Date: January 14, 2007

To: T10 Committee (SCSI)

From: George Penokie (IBM)

Subject: SAS-2: SAM-4: Miscellaneous State Machine Fixes

Figure 1 — SL (link layer for SAS phys) state machines (part 1)

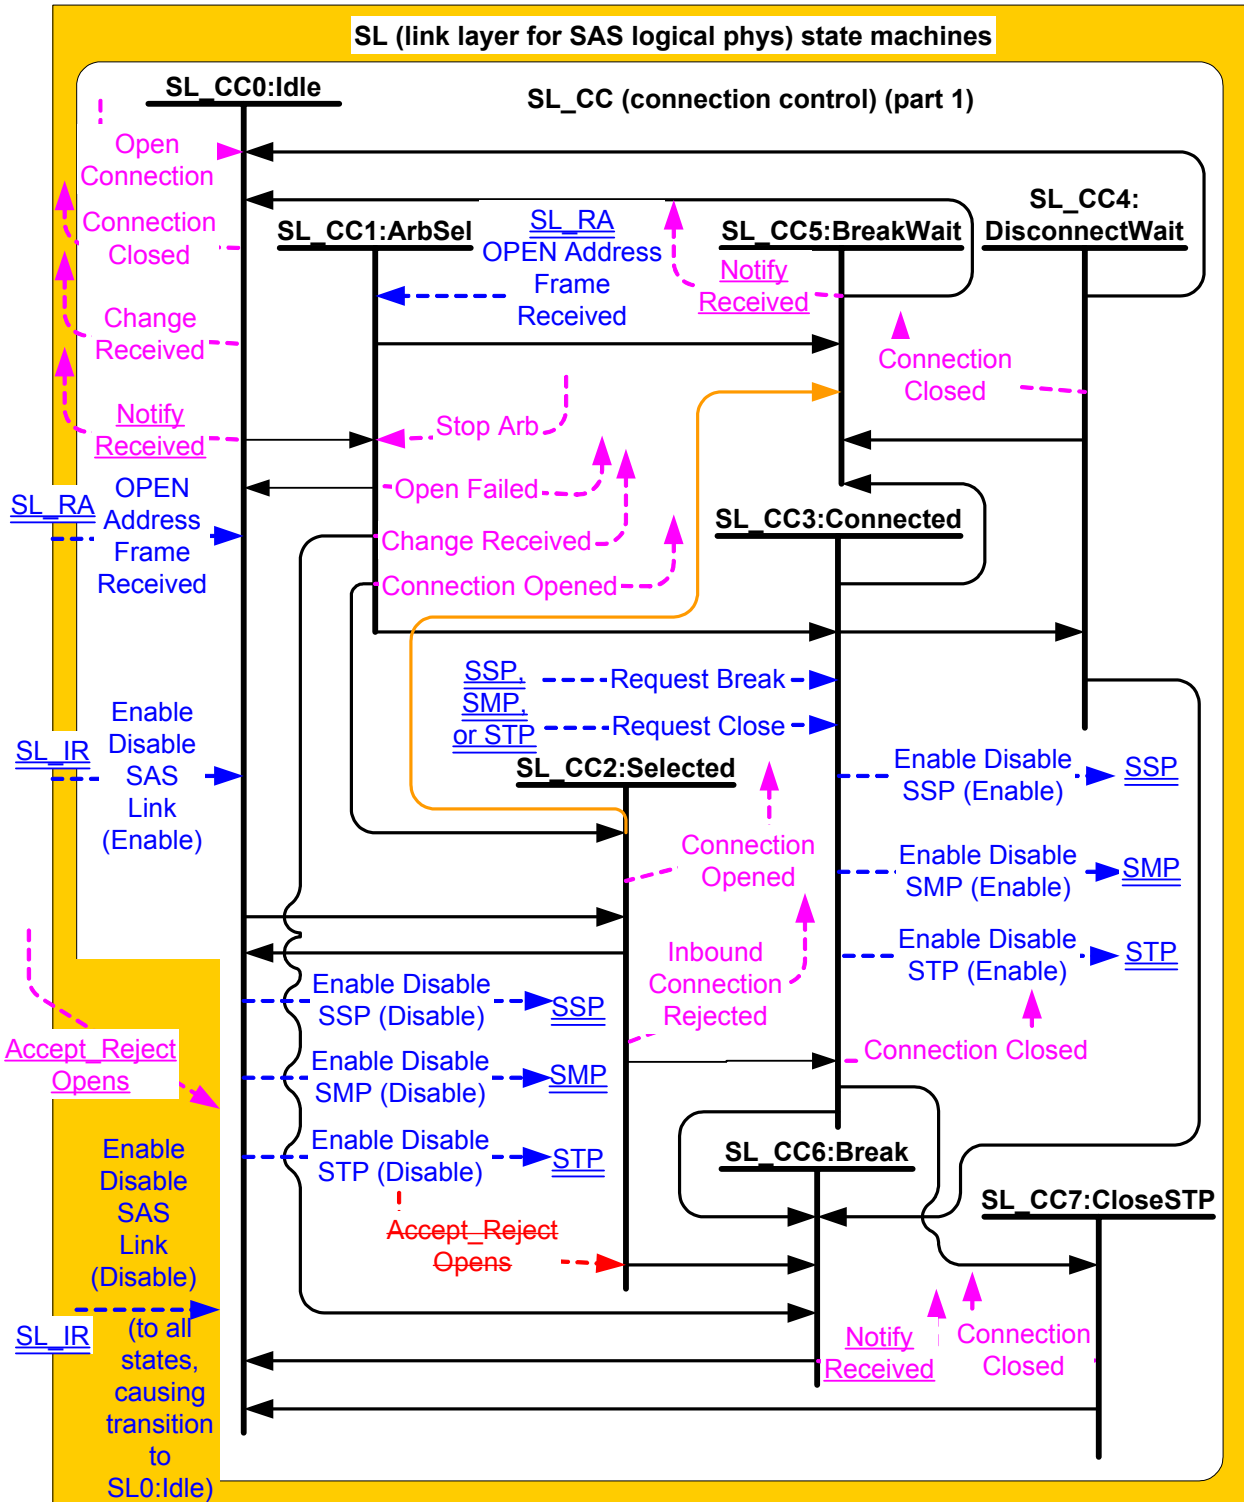
Editor's Note 3: Figure 1 has changed. The changes are indicated by the orange arrow and by underlines on the confirmations, requests, and messages.

Figure 2 — SL (link layer for SAS phys) state machines (part 2)

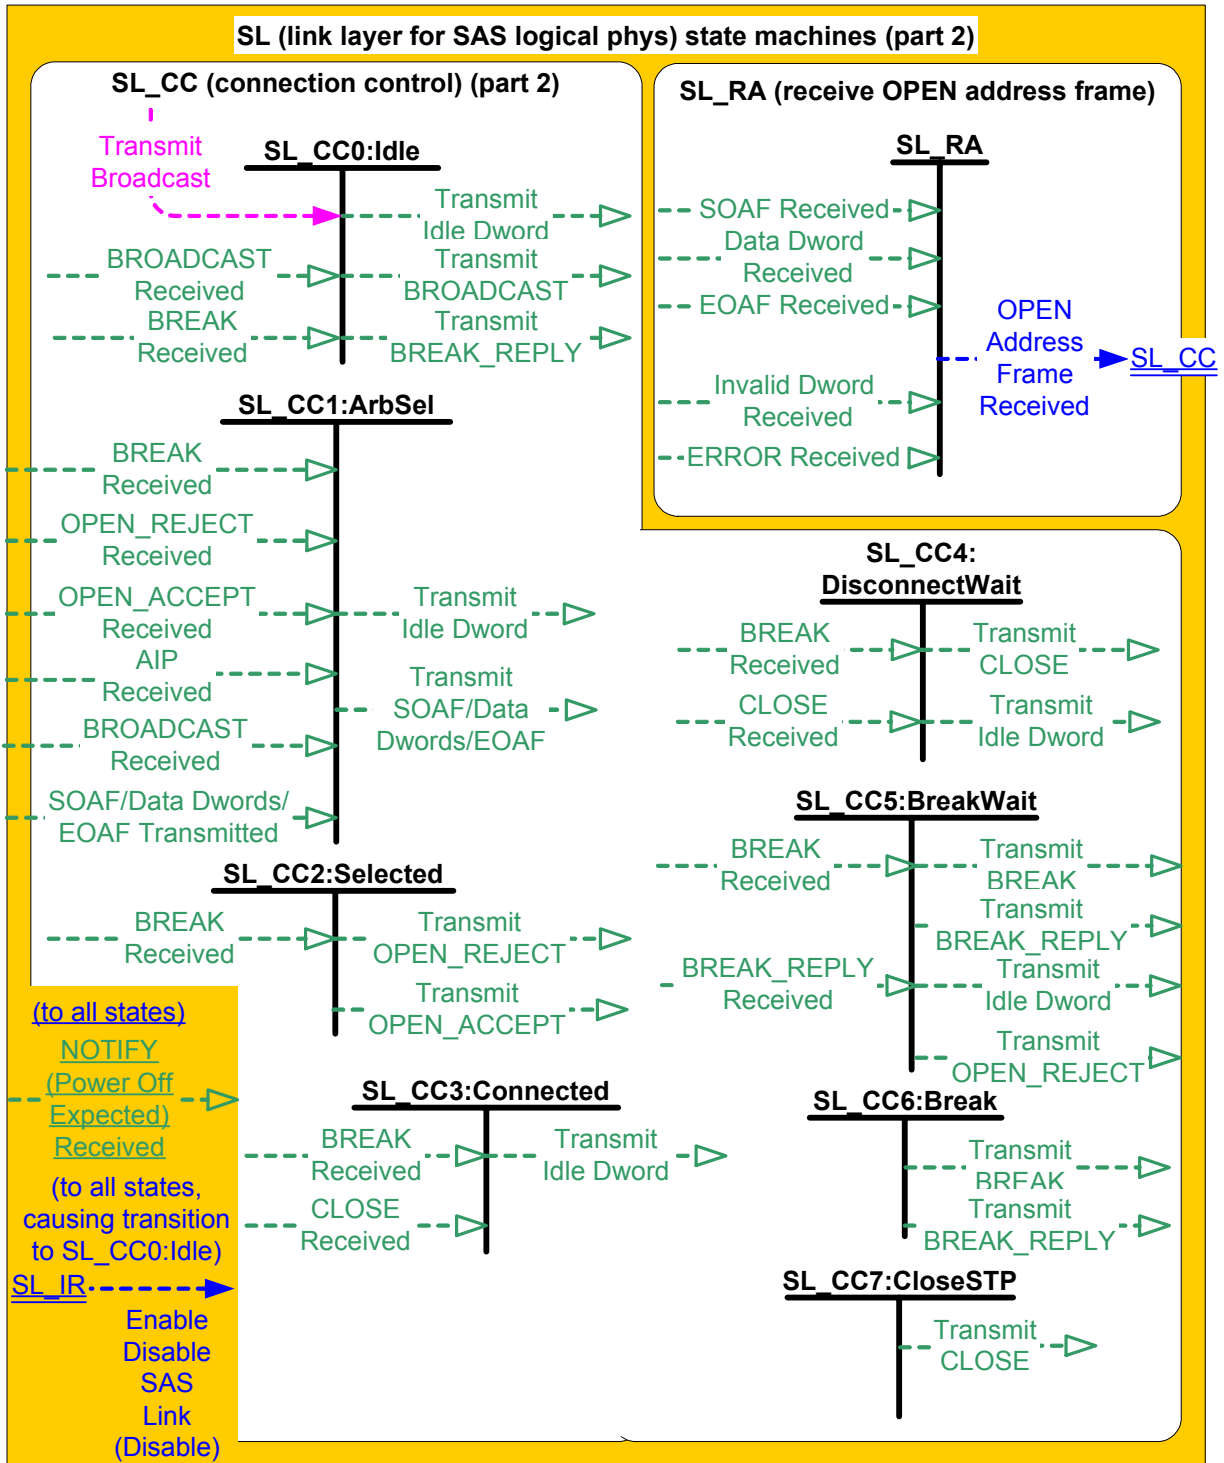
Editor's Note 4: Figure 2 has changed. The changes are indicated by underlines on the confirmations, requests, and messages.

Figure 3 — SSP (link layer for SSP phys) state machines (part 1 - frame transmission)

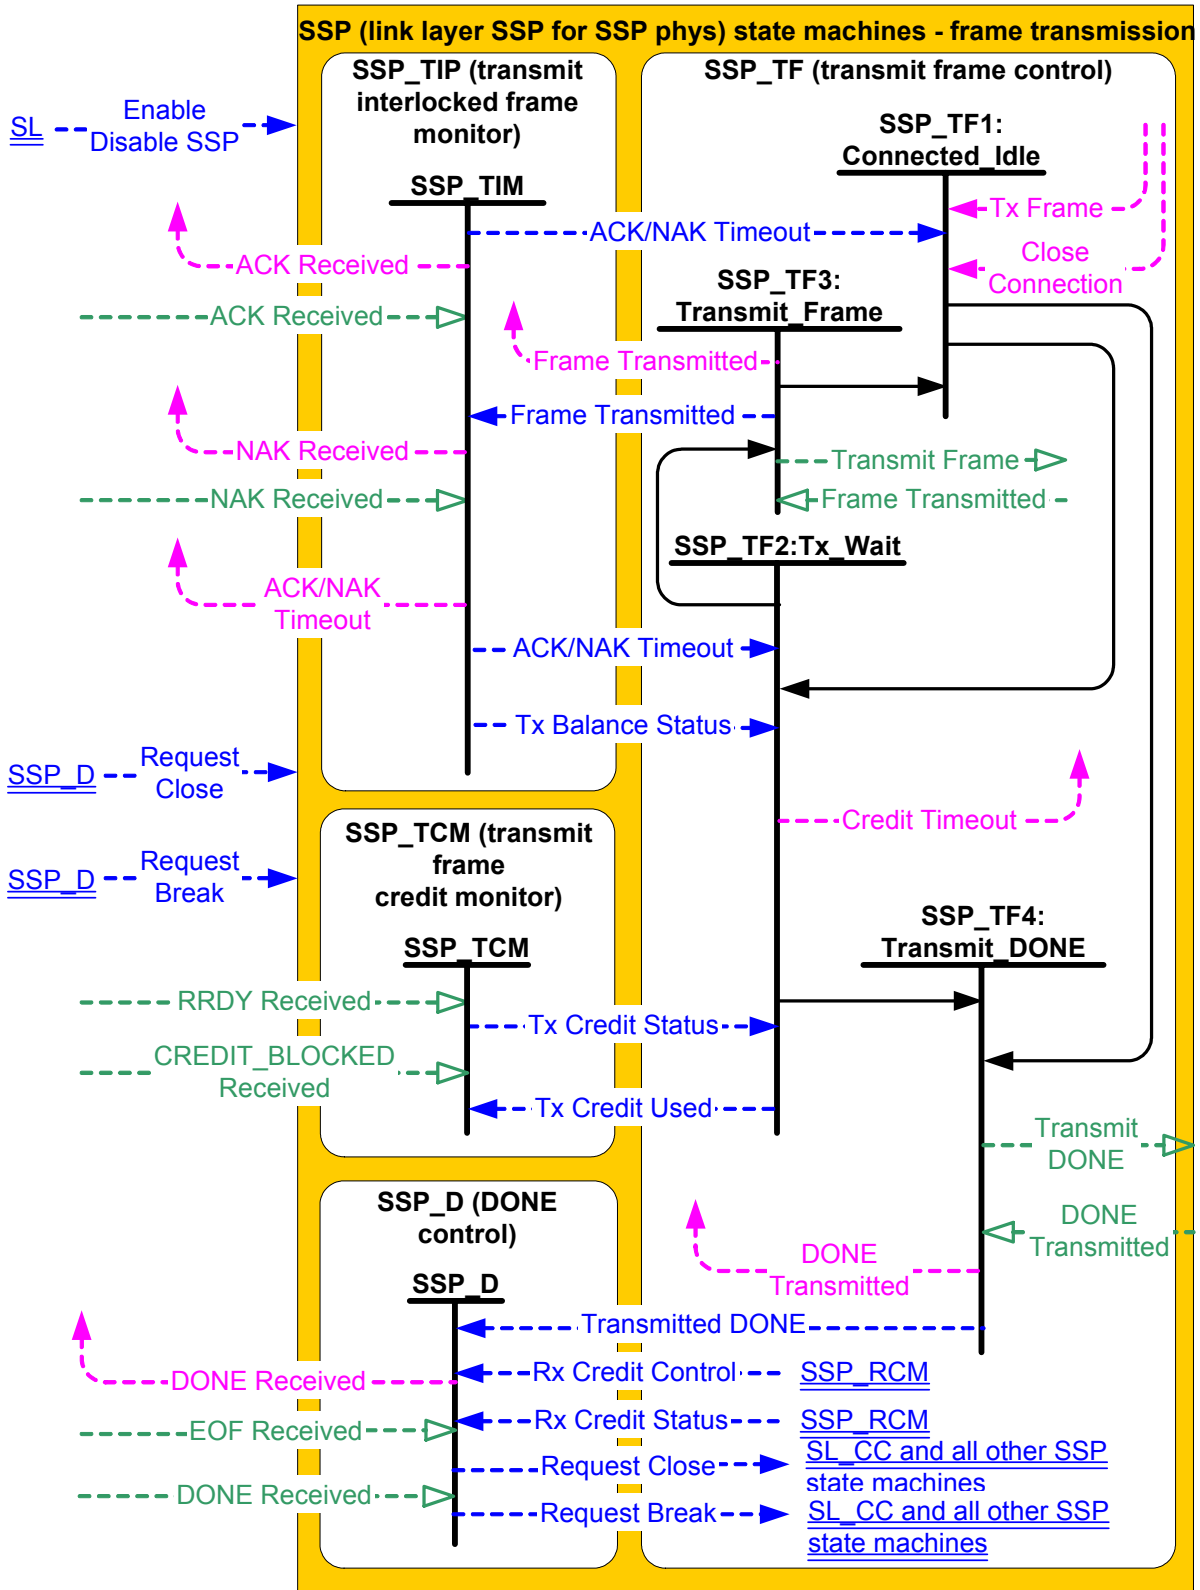
Editor's Note 6: Figure 3 has changed. The changes are indicated by underlines on the confirmations, requests, and messages.

Figure 4 — SSP (link layer for SSP phys) state machines (part 2 - frame reception)

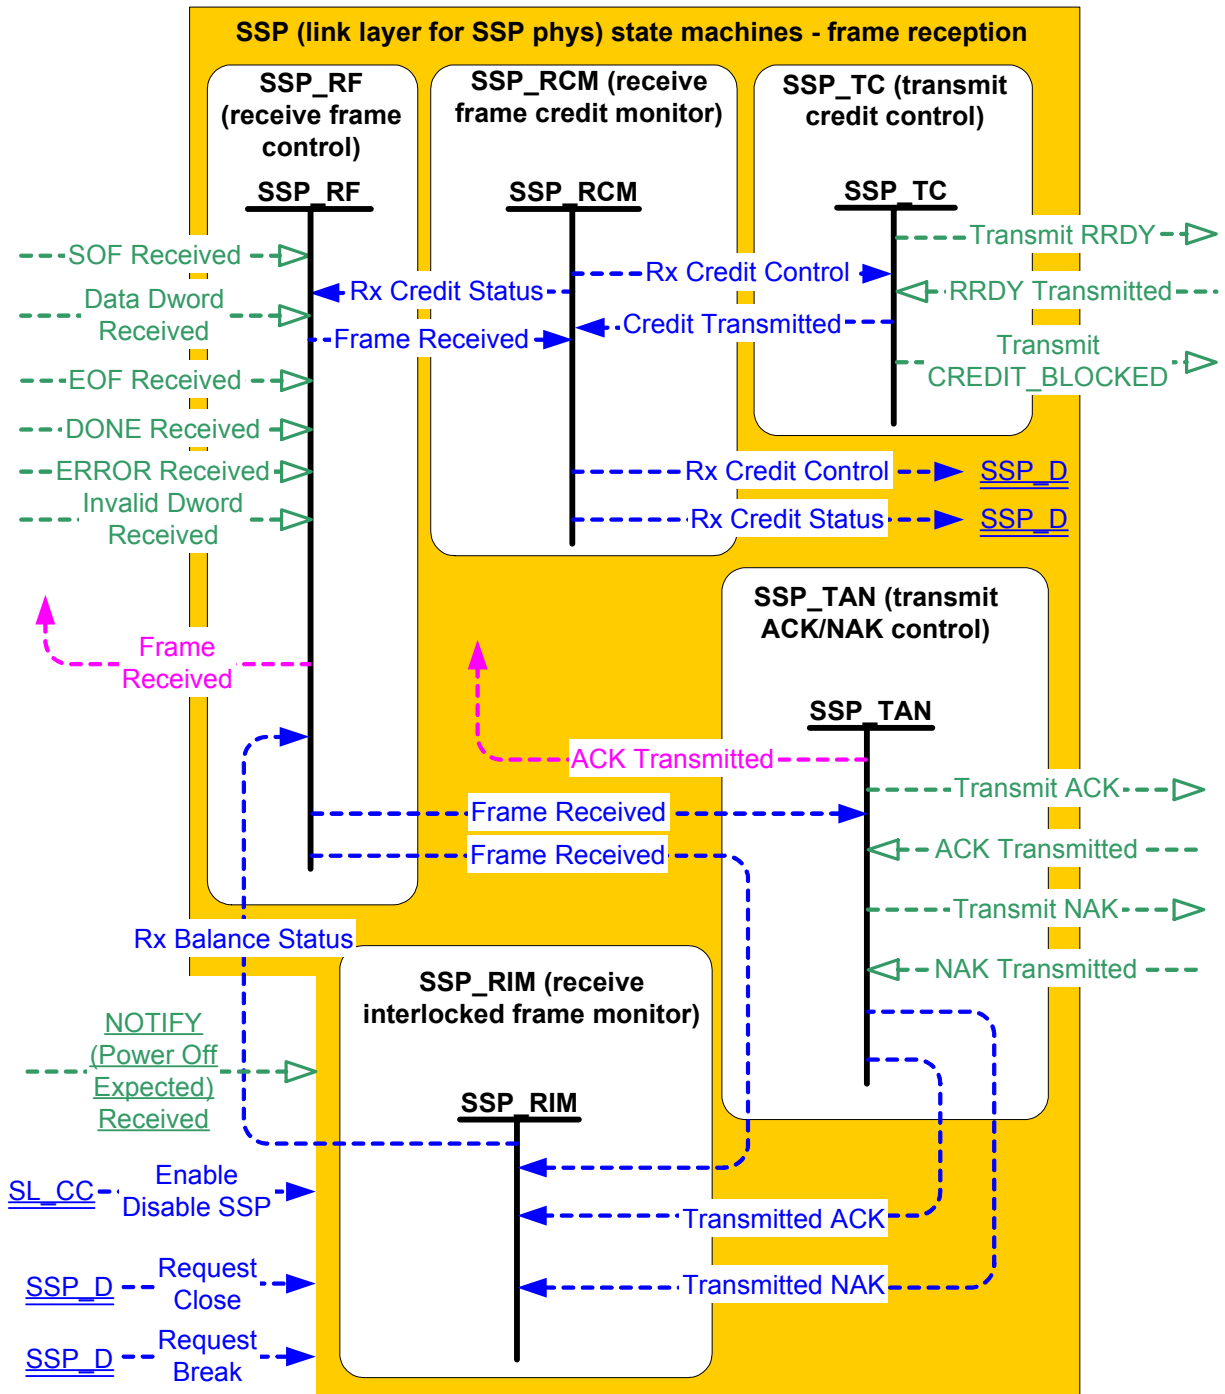
Editor's Note 5: Figure 4 has changed. The changes are indicated by underlines on the confirmations, requests, and messages.

Figure 6 — ST\_T (transport layer for SSP target ports) state machines

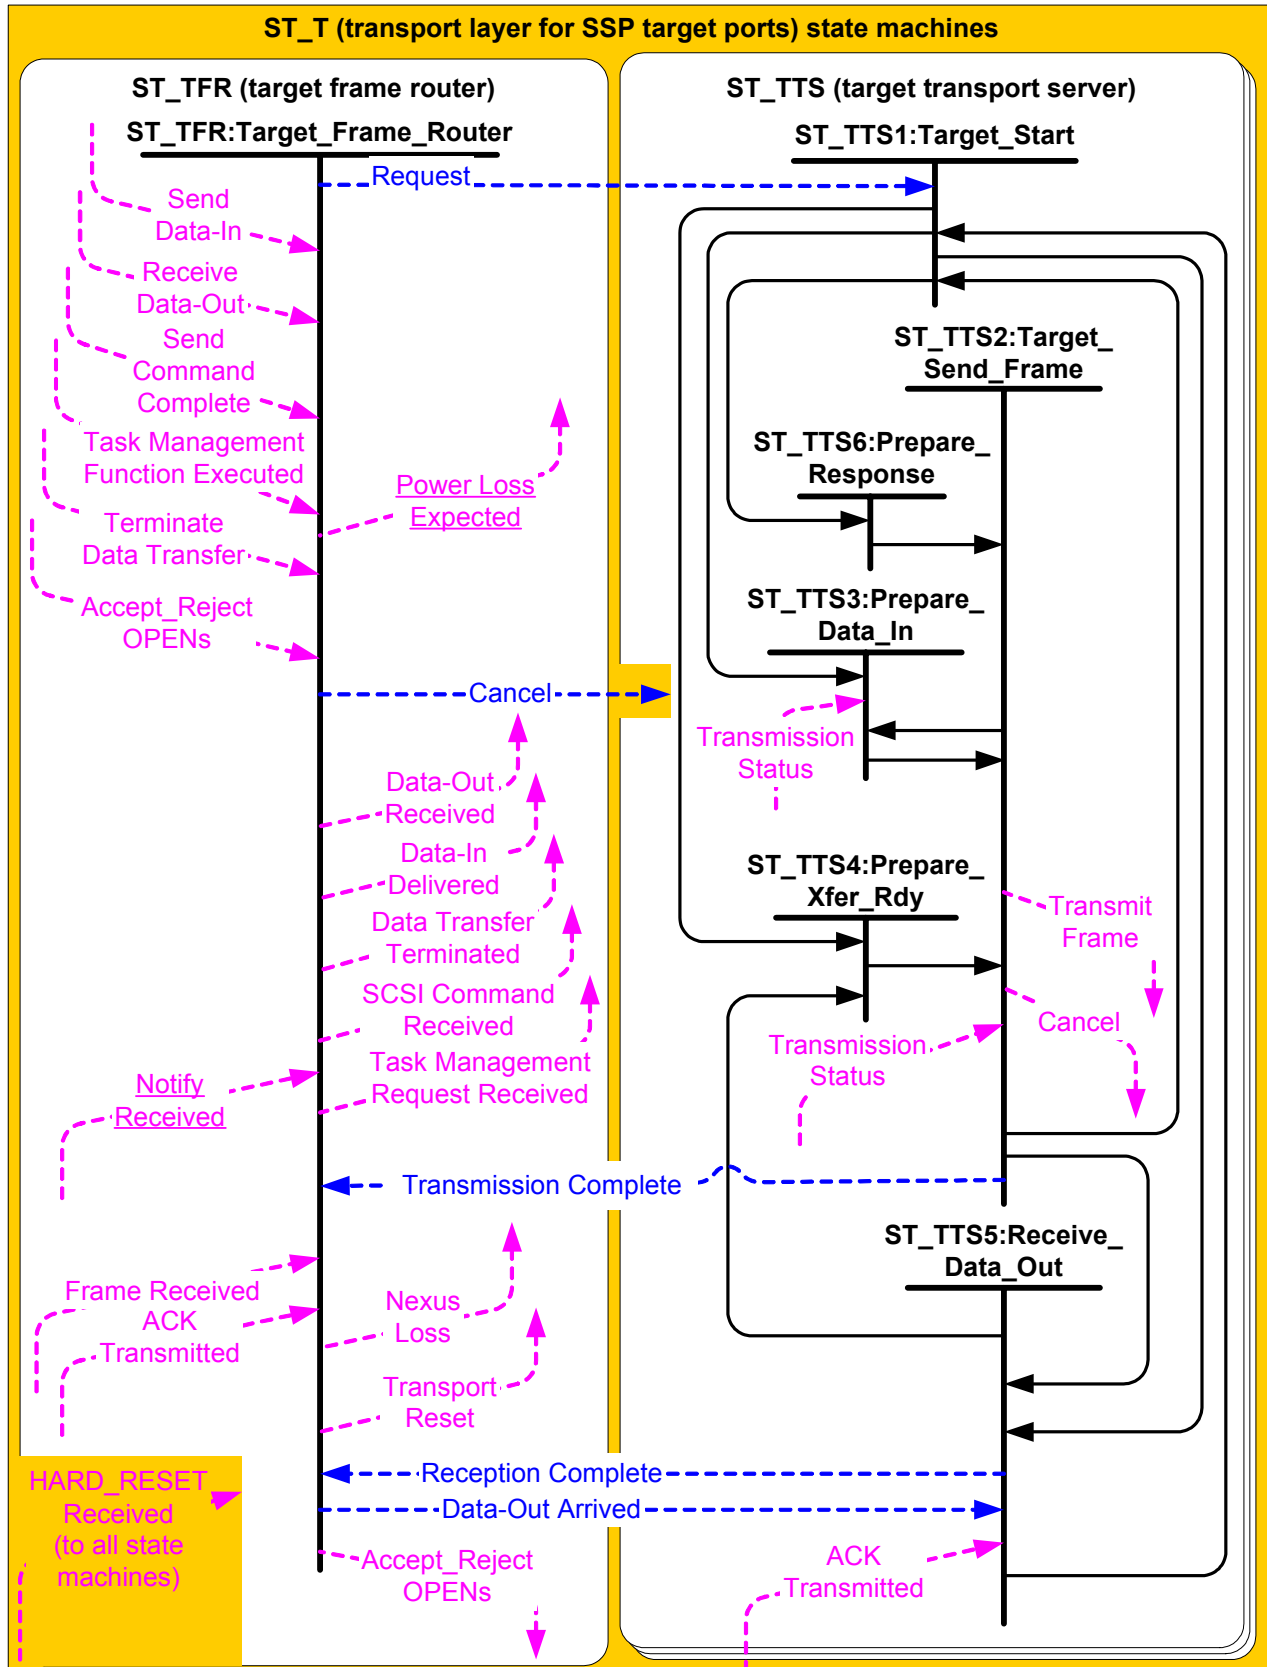
Editor's Note 2: There needs to be a Transmission Status confirmation arrow added to the ST\_TTS5: Receive\_Data\_Out state in the ST\_T state machine figure.

Figure 7 — Events and event notifications for SCSI target devices

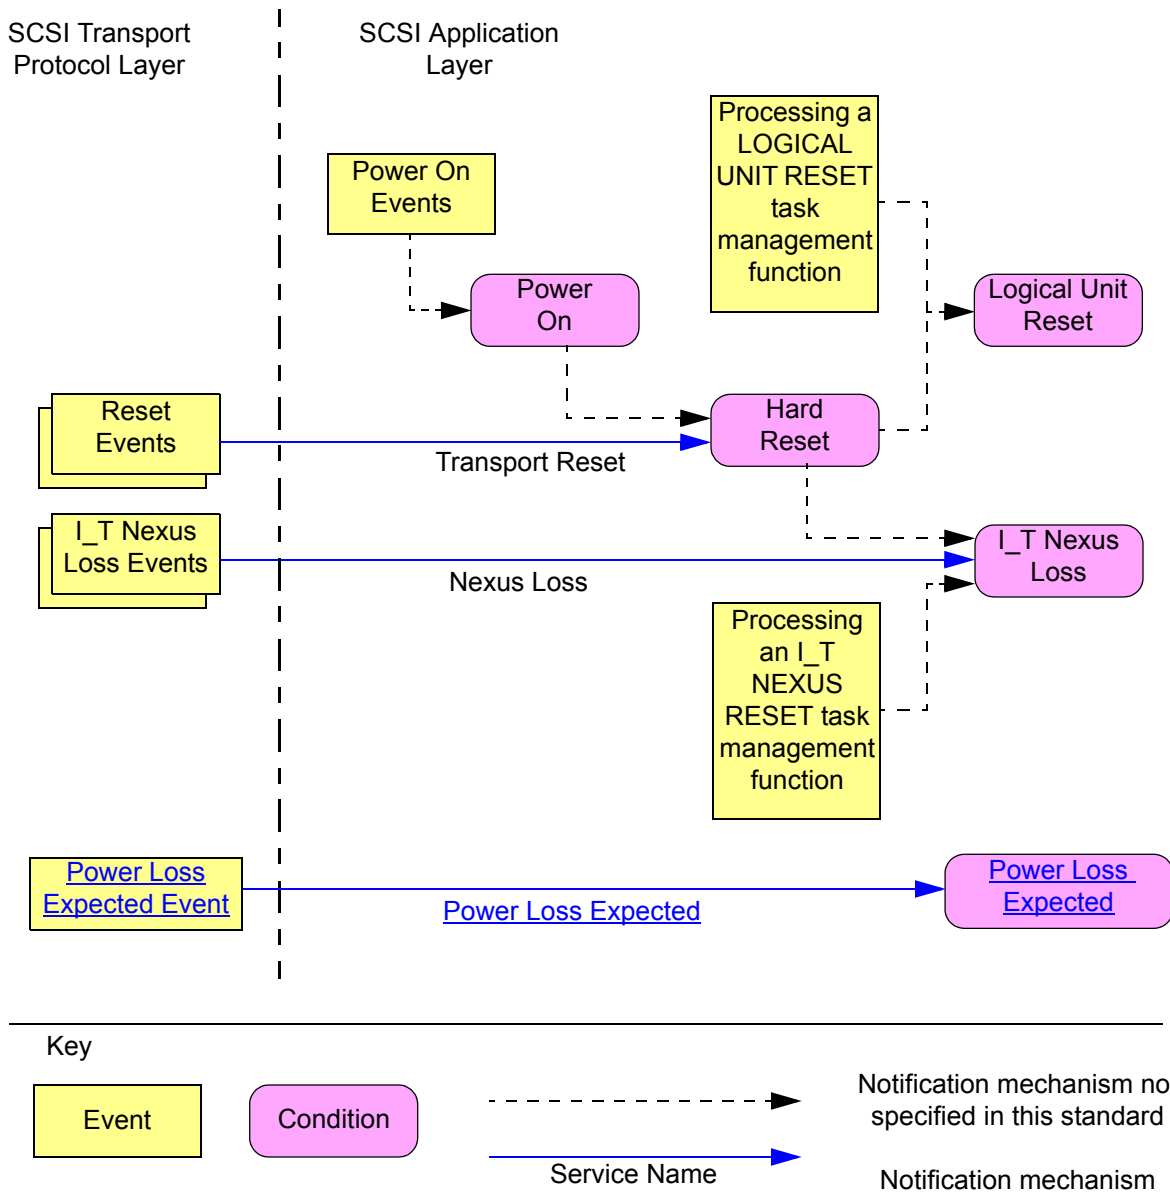
Editor's Note 8: Figure 5 has changed. The changes are indicated by blue underlines.
